TAMAHERE
COUNTRY CLUB

STAGE 3 Extension

Tamahere Country Club Extension Infrastructure Report:

SUBJECT: S92: LUC0060/24-LDE response- 3 Waters mattersTamahere Country Club (TCC)-Stormwater

Figure 2: Hydraulic Toolbox result for the line to MH3-E

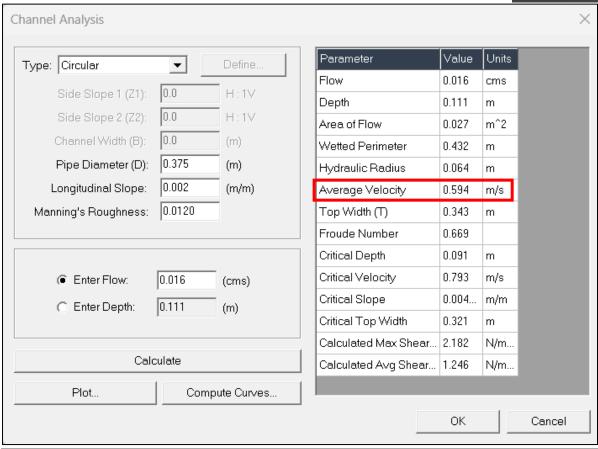
It is not clear within the Kotare report if the pipe grades (0.33% and 0.4% instances) proposed within the drawing detail have been assessed by Te Miro to meet suitable self-cleaning velocities as per RITS minimum grade.

The pipeline to MH3-E is having the lowest velocity in the east precinct. Figure 2 shows the average velocity for a flow of half the 2 Year design storm is 0.6m/s (1dp), this meets the RITS minimum values as per RITS.
